CITY OF WESTMINSTER				
PLANNING	Date	Classification		
APPLICATIONS SUB COMMITTEE	6 July 2021	For General Release		
Report of		Ward(s) involved		
Director of Place Shaping and Town Planning		Lancaster Gate		
Subject of Report	10 and 11 Queen's Mews, London, W2 4BZ			
Proposal	Rear extension at ground, first and second floor levels [at no. 10], reconfigured windows at rear [nos. 10 and 11] and the creation of terrace with railings in front roof slope [at no. 10].			
Agent	Ms Ghazala Hussain			
On behalf of	Ms And Mr Wong and Fairington			
Registered Number	20/08153/FULL	Date amended/	2 March 2021	
Date Application Received	21 December 2020	completed	Z IVIAICII ZUZ I	
Historic Building Grade	Unlisted			
Conservation Area	Bayswater

Reference: 20/08153/FULL

Front Elevation of 1 - 10 Queen's Mews

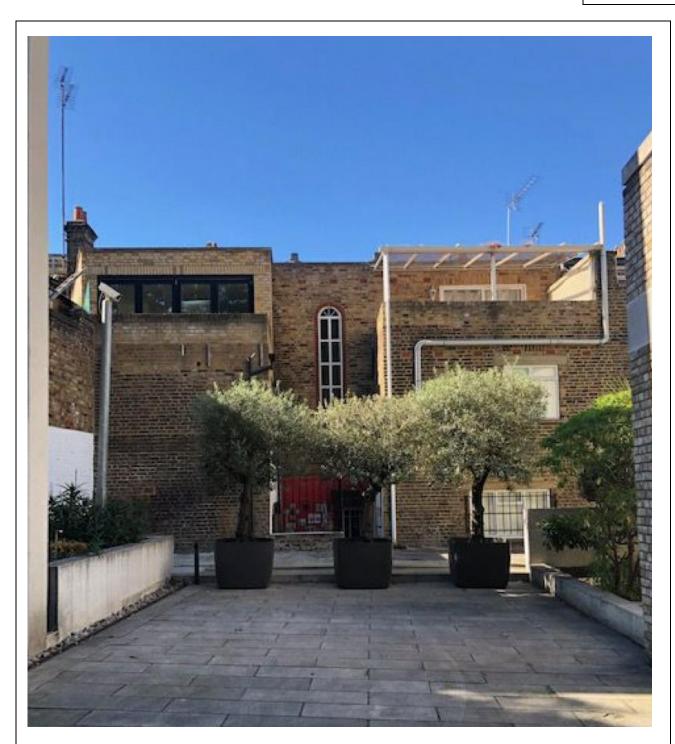
Objection on grounds that the proposed front terrace will cause noise disturbance, overlooking of the houses opposite and cause a loss of privacy. The roof terrace at no. 8 should not be a precedent and will be out of keeping with architectural cohesion of the mews and not enhance the conservation area.

- The front roof terrace would not enhance the conservation area
- The front roof terrace does not match with the roof terrace no. 8

- The front roof terrace would create overlooking and privacy issues
- The front roof terrace would create light pollution
- The front roof terrace would create noise disturbance
- The front roof terrace at no. 8 already causes issues for no. 15
- The front roof terrace would create social disharmony and poor neighbourly relations
- The rear roof extension would cause a loss light to rear roof terrace at no. 9

As the proposed roof terrace at no. 10 preserves part of the original profile of the roof and its tiled appearance, its impact on the uniformity of the southside of the Queen's Mews with the exception of the arrangement at no. 8 is considered to be limited. Due to the proposed balustrade being set back from the eaves line and being behind part of the retained roof slope they will be visually more subtle than those which are lawful at no. 8. On this basis the proposed roof terrace and balustrade arrangement are considered to be much more sympathetic to the original appearance of the roof, the host building and surrounding townscape and given this, is therefore not reasonable to argue that the proposal will generate any additional visual harm to constitute grounds to refuse permission on in design terms. Due to the proposed roof terrace and associated balustrade being considered to be an improvement on what is permitted at no. 8, the objection raising concern that the proposal will not match with no. 8 cannot be sustained as grounds to refuse the application.

Whilst this it is recognised that there will be some overlooking, as raised in the objections by neighbours, the overlooking is not considered to be unacceptably harmful to the privacy of neighbours at nos. 12-15. The overlooking will be mutual and therefore no more invasive to one neighbour than it will be to another. Furthermore, the existing rooflights to be removed to create the roof terrace already offer the same views that would be attainable from the proposed roof terrace. The roof terraces at nos. 12-15 are therefore already somewhat overlooked which means that the proposed roof terrace may make little difference to the privacy of those in nos. 12-15. The objections raising concern over overlooking therefore cannot be sustained.

Proposed Section of no. 10 Queen's Mews

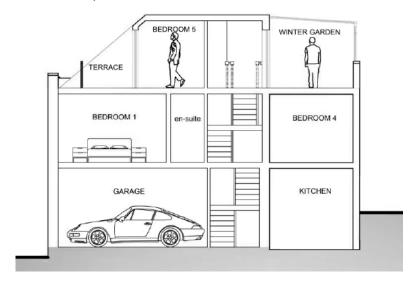
It is proposed that the centre of the front roof slope is removed to create space for a roof terrace set within the retained roof slope to the front and the sides maintaining the slope and roof slates around the outer roof profile. There will be a balustrade set behind the front roof pitch and a central opening door with windows either side.

Above the existing rearward facing roof terrace and the two storey it is proposed that the half width canopy is removed and replaced with a glass enclosure across the full width of the elevation, in association with the proposed rear extension on the storeys below, effectively creating a fully enclosed glazed winter garden. It is recognised that the existing structure is in a poor state of repair. Whilst, by virtue of its increased scale the framing will be more visually prominent, however by virtue of its detailed design, including the slender framing, it is not considered to dominate the elevation or result in high level bulk which detracts from the host building. Furthermore, it can be argued that it enhances the appearance of the building through replacing an untidy structure. As such the proposal is considered to accord with the aims of policies 38 and 40 and will preserve the character and appearance of the conservation area.

The roof of the proposed sunroom is to shown to be at approximately the same height as the existing canopy which is to be removed as a part of the works. It was raised in an objection that the sunroom would cause a loss of daylight and sunlight to the adjacent roof terrace at the neighbouring no. 9 Queen's Mews. Due to the proposed sun room being principally formed of glazing and matching the height of the existing structure, it is

Notwithstanding the details shown on the approved drawing all new fenestration frames shall be constructed in timber and maintained as such hereafter.

Notwithstanding the details shown on the approved draws all new railings shall be painted black and maintained as such hereafter.
